# IAE Propulsion System NON-MODIFICATION SERVICE BULLETIN

Subject: Transmittal of Revision 1 to Service Bulletin Number V2500-NAC-26-0014

# V2500-NAC-26-0014

**NACELLE - POWERPLANT – FIRE PROTECTION – CORE ZONE FIRE DETECTOR –  
INSPECTION AND REPLACEMENT OF FIRE DETECTOR CLAMPS  
(NON-MODIFICATION SERVICE BULLETIN)**

Removal and installation of the responder housing clamps  
Figure 1

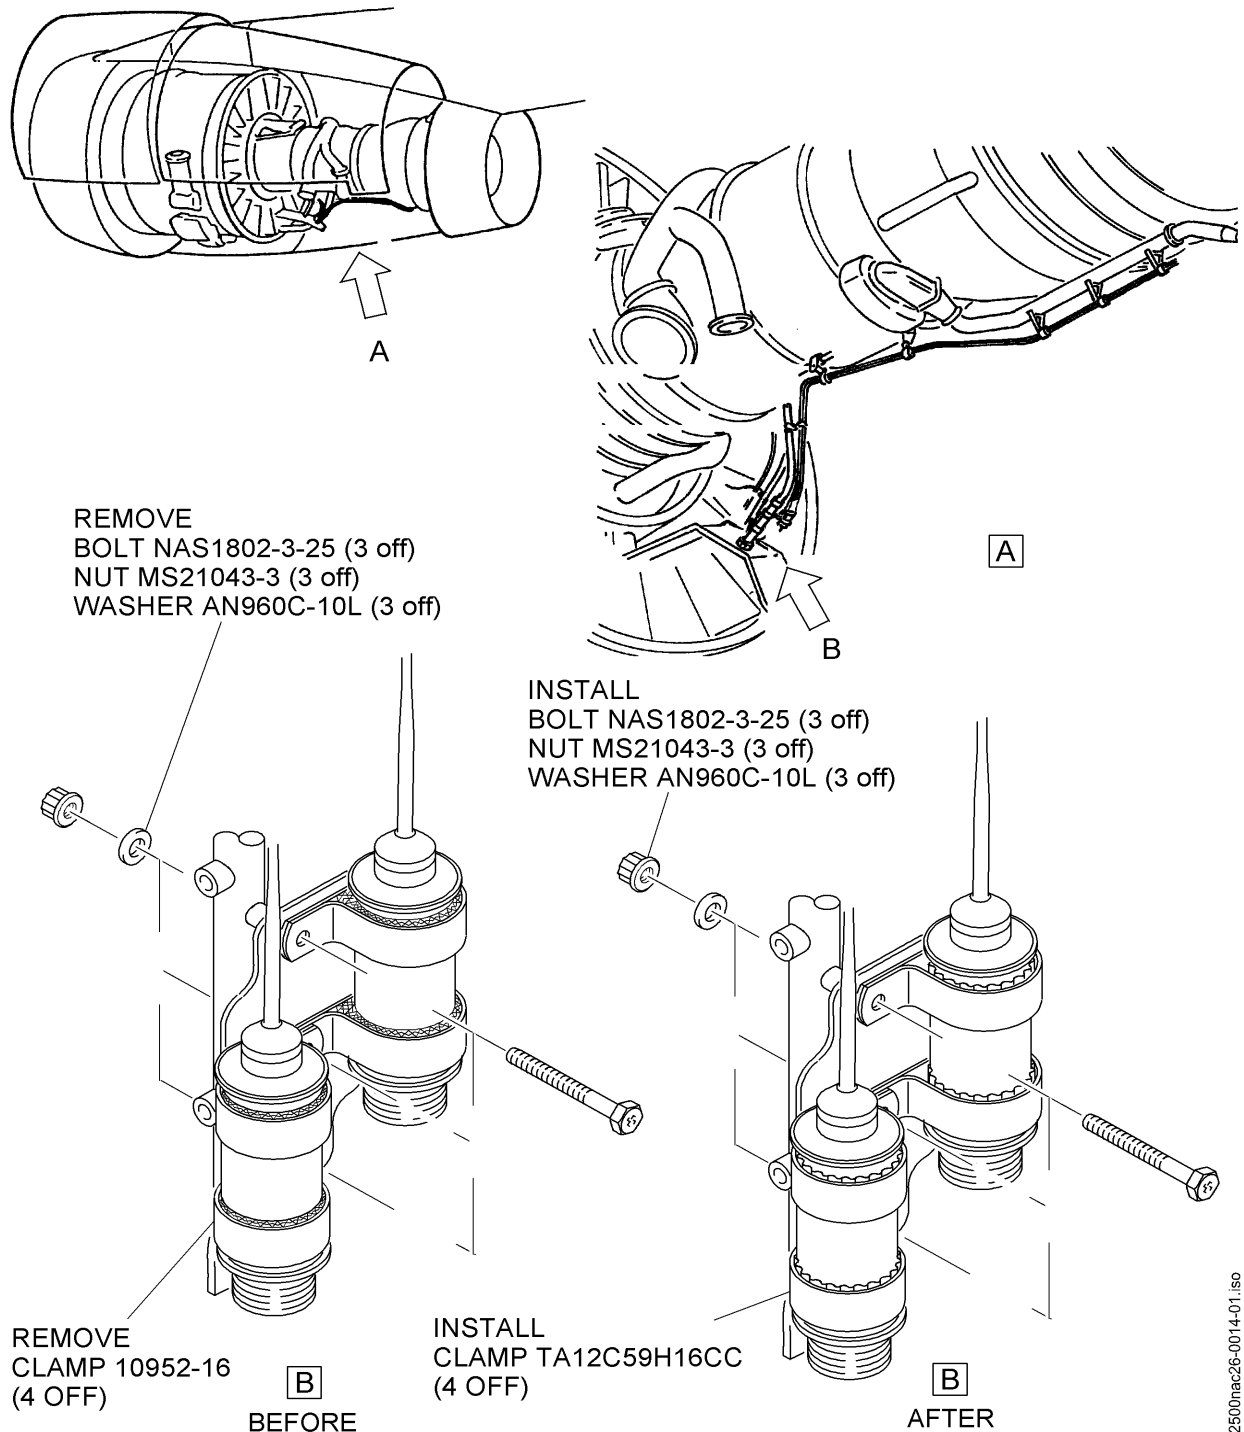
A number of unapproved clamps have been installed on the core fire detector assembly. These clamps attach the core fire detector responders to the fire detector rail. It has been discovered that the unapproved clamps, part number 10952-16 may not apply sufficient clamping force to hold the responder housings in place. This could cause the responders to become loose inside the clamps.

- (3) Do a general visual inspection of the core fire detector (4001WD1) 7827-02 and (4001WD2) 7827-02 and the responder housing clamps as follows. Refer to Figure 1.

- (a) Identify the clamps that attach the two 3601-97 responder housings to the 8246 firewire bracket.
  - (b) If the responder housing clamps are identified as ADEL Part Number 10952-16 with a braided wire insert they must be removed and replaced with Part Number TA12C59H16CC clamps as instructed in Part B.

- (1) Remove the three NAS1802-3-25 Bolts, MS21043-3 Nuts and AN960C-10L Washers that attach the four 10952-16 Clamps to the responder housings. Remove and discard the four 10952-16 Clamps and the braided wire inserts.
- (2) Install four new TA12C59H16CC Clamps and inserts with the NAS1802-3-25 Bolts, MS21043-3 Nuts and AN960C-10L Washers removed in Step (1).

- (3) Torque the NAS1802-3-25 Bolts to between 20 and 25 pounds inches (2.26-2.83Nm). Make sure the responder housings do not rotate or slide within the clamps.
- (4) Close the thrust reverser halves as instructed in the Aircraft Maintenance Manual (M-V2500-1IA) Task 78-32-00-410-010.
- (5) Close the left and right fan cowls as instructed in the Aircraft Maintenance Manual (M-V2500-1IA) Task 71-13-00-410-010.
